City of
Richmond

Report to Development Permit Panel

File: DP 17-790086

Re: **Application by Jhujar Construction Ltd. for a Development Permit at 9291 and 9311/9331 No. 2 Road**

1 FIRE ACCESS PLAN
 A-101 SCALE: 3/32" = 1'-0"

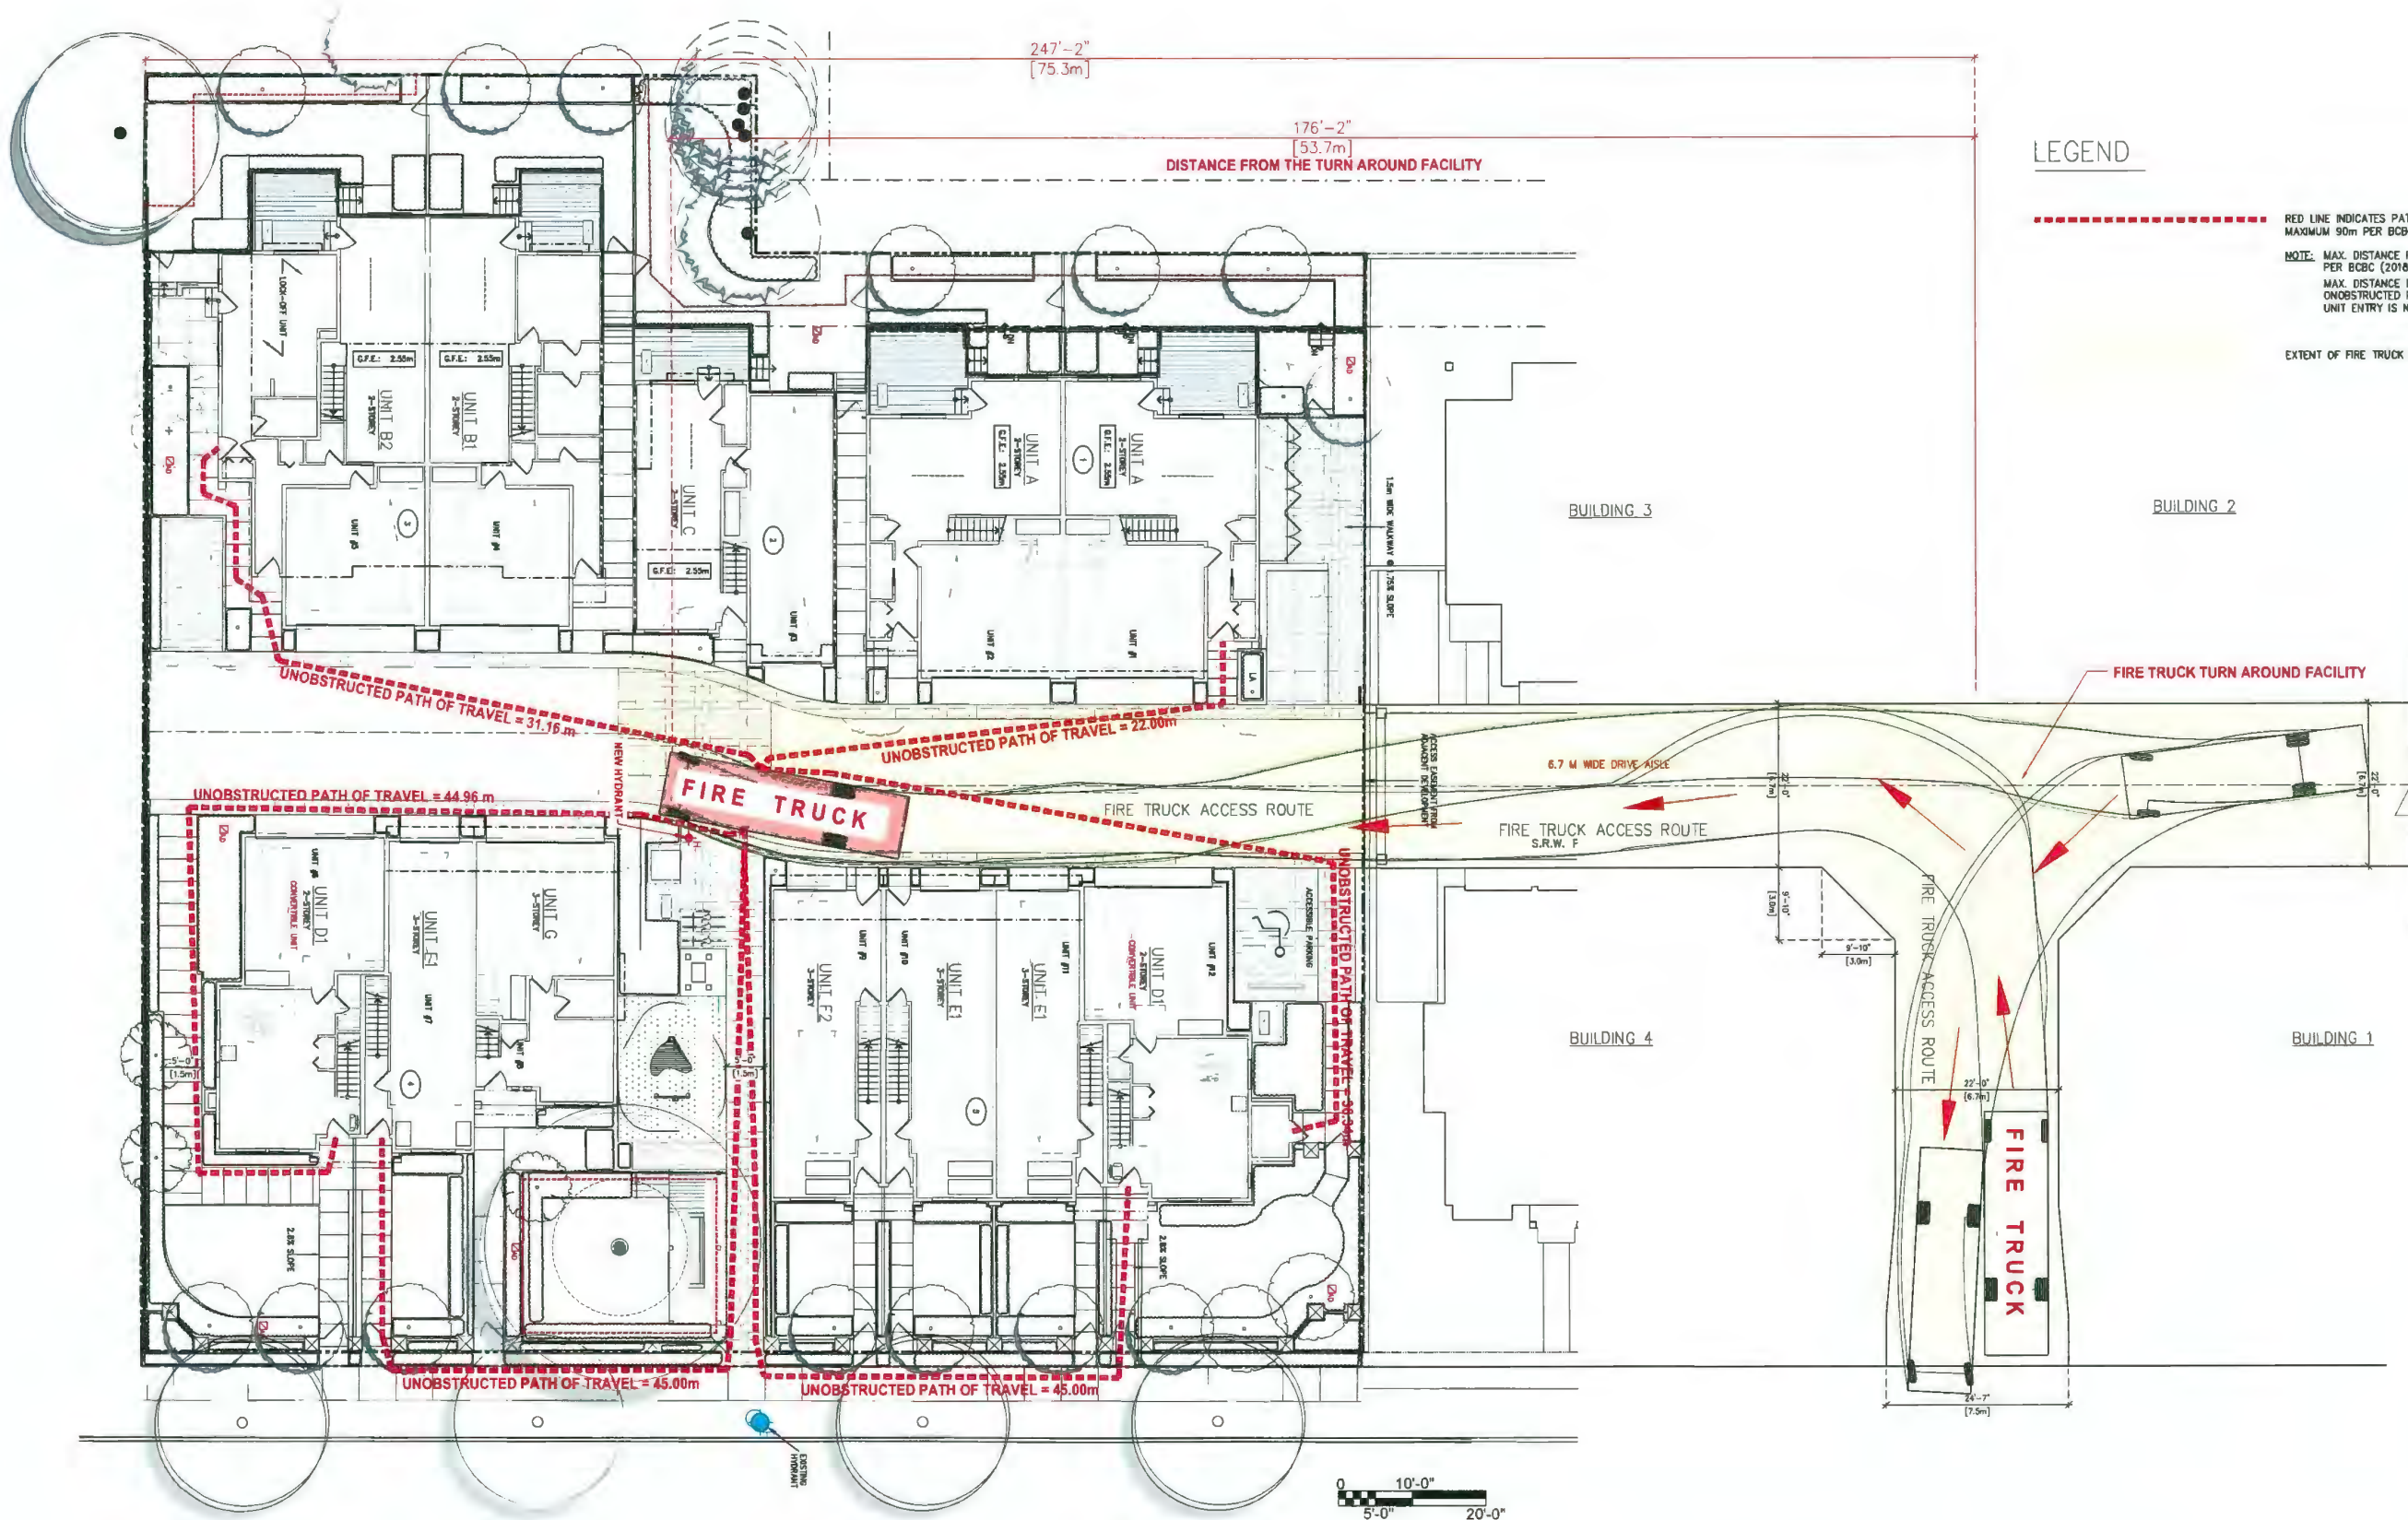
- appreciate the drawings and site layout presented by the applicant;
- support the Panel comment that the provision of three pedestrian walkways is not necessary; the north and middle walkways would be sufficient and ensure that these walkways are accessible for people with disabilities; the space for the south walkway could be utilized for additional soft landscaping;

Walkway connecting to the sidewalk previously along the South property line has been revised and a 5ft. wide Firefighters access has been provided to access the main entrance of the unit D1 in building 4. A landscaping buffer has been provided at the South property line along this Firefighters access.

2 NORTH ELEVATION
A-301 SCALE 3/16" = 1'-0"

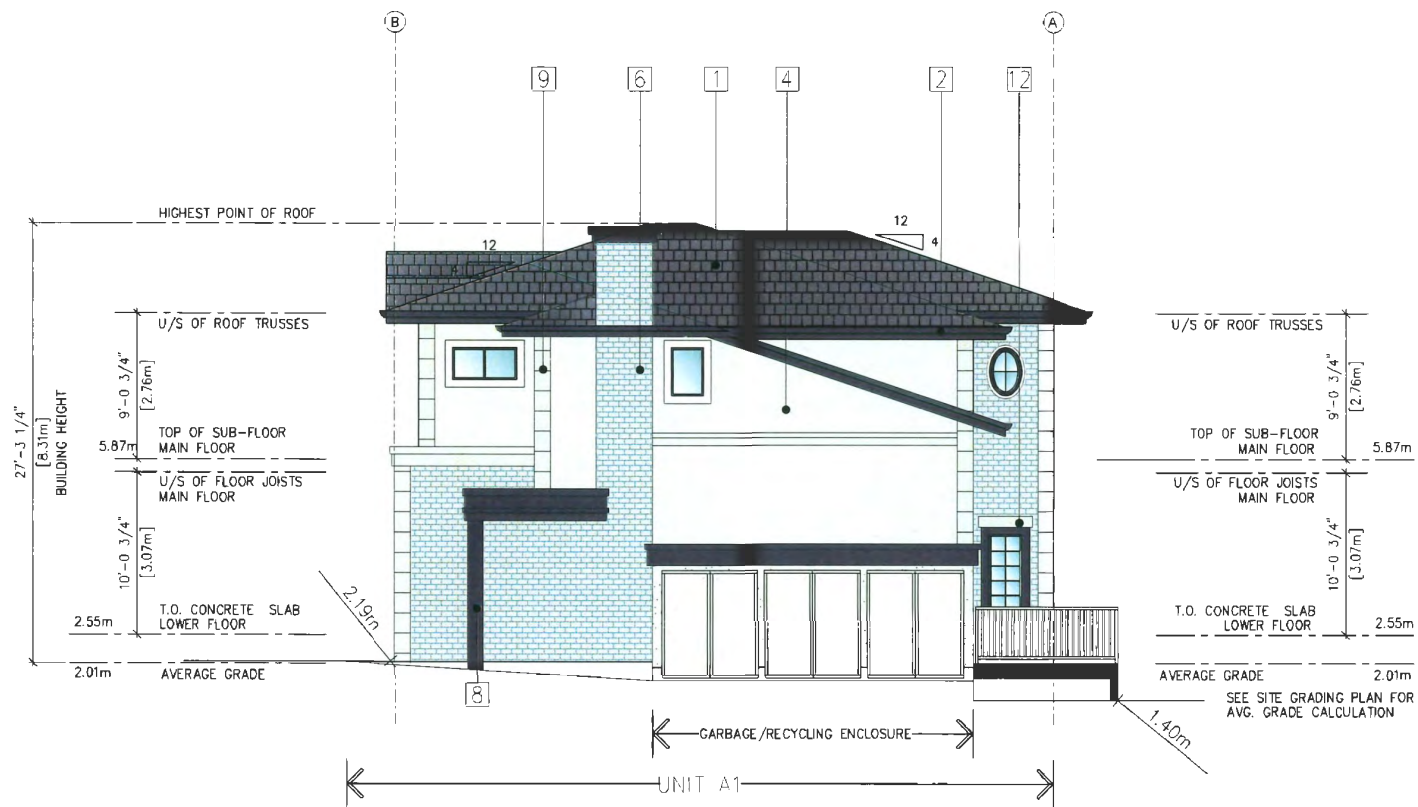
- consider installing additional glazing on the north elevation of Building 1 to provide passive surveillance opportunity over the vehicle entrance to the development and the visitor parking area;

North elevation of building 1 has been revised with overall massing being reduced by using a lower slope for the roofs and addition of another window on this side to improve passive surveillance opportunity over the vehicular entrance to the development and the visitor parking area.
